Consolidation Coal Company
Western Region
2 Inverness Drive East
Englewood, Colorado 80112
(303) 770-1600

re: Apparent Completeness Review - Preparation Plant and Loadout

This submittal is intended to address the deficiencies listed in the "Apparent Completeness Review" sent to Mr. Carl Muha on January 20, 1982.

DIVERSION INFORMATION SHEET

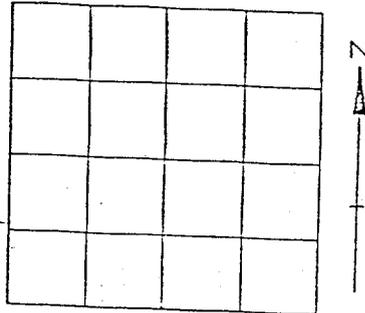
OGM COMMENT

The northern ditch of the main entrance road has been designed to intercept the drainage from the plant site diversion ditch. These calculations are included in the preparation plant application. Refer to pages 15-53 through 15-55. With the completion of the final plant yard design the profile of the diversion has been revised (refer to Plate 15-10). A copy of this revised upper reach calculation sheet, page 15-54, is included here to reflect the change in grade.

The southern ditch of the main entrance road as well as the ditchlines for the coal refuse haulage road and plant access road are designed as small triangular cuts with minimum side slopes of 2:1 and minimum depths of 1 foot. The 10 year - 24 hour runoff is so small that even this triangular section is overdesigned, however equipment used to construct the ditches limits the minimum size, rather than the expected runoff. A calculation sheet is included giving the design for the worst possible case and proves that the ditches are adequately designed as shown on the drawings.

REFUSE HAULAGE ROAD
 QUITCHUPAH CREEK CROSSING

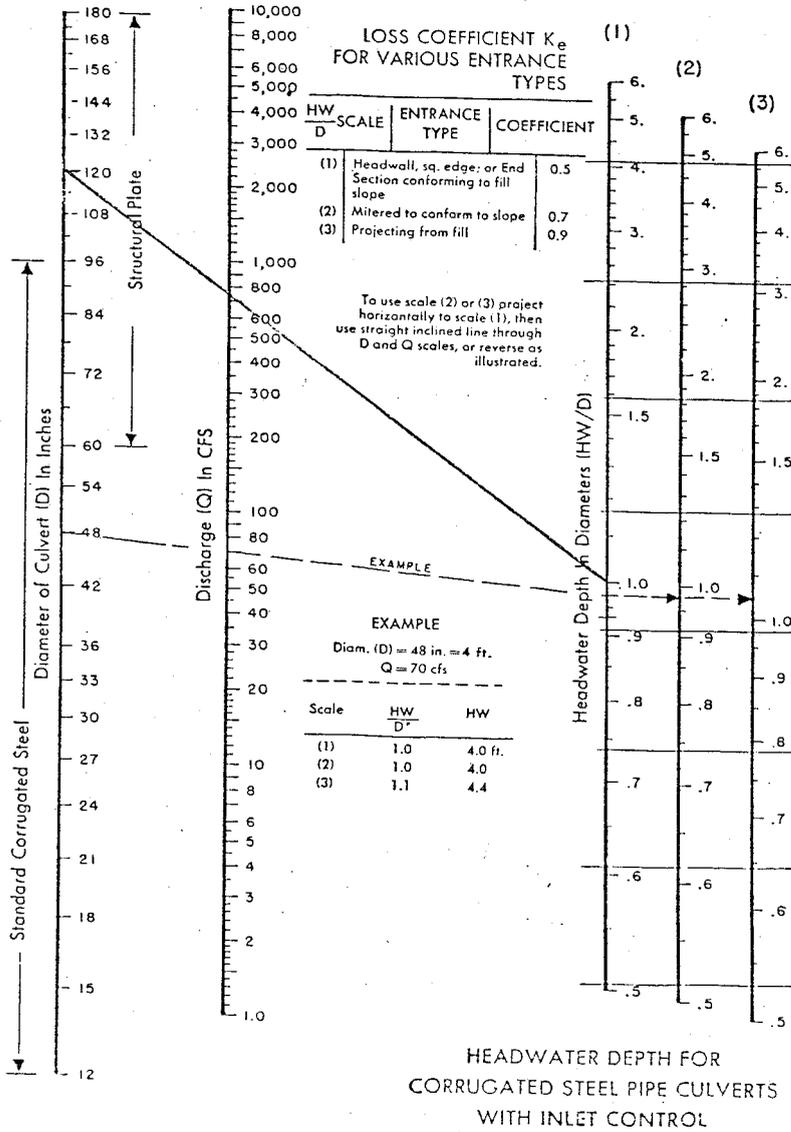
Applicant shows cross section and profile of 3-120" culverts for Quitchupah Creek crossing. Submit design criteria and calculations used for culvert design. Pursuant to 817.153(c)(1)(i)-.163, culverts should be sized to safely pass the 10-year, 24-hour precipitation event. Plans for compliance with 817.153(c)(1)(ii-v)-.163 must be submitted.

REFUSE HAULAGE ROAD
CROSS CULVERT

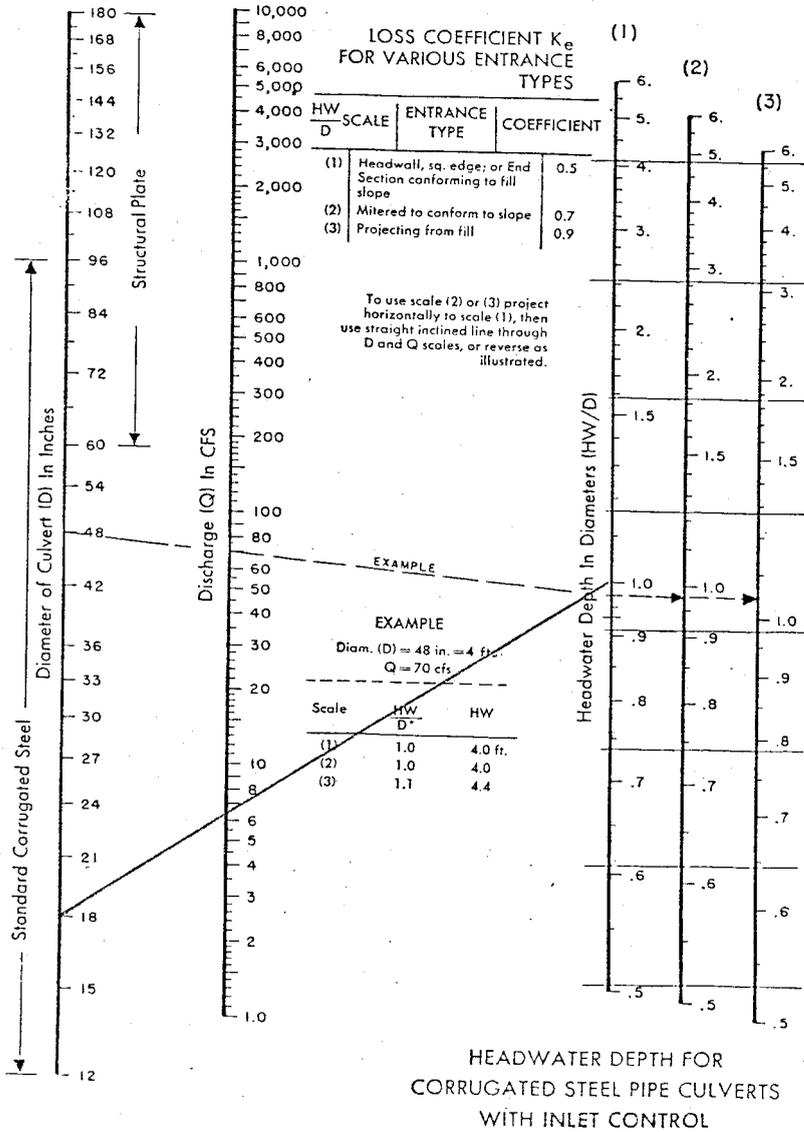
817.163(c) The applicant must provide plans to install culverts along the coal refuse haulage road that meet the requirement of part (2)(i). Culvert design must incorporate the requirements of Parts (2)(iv) through (vi).
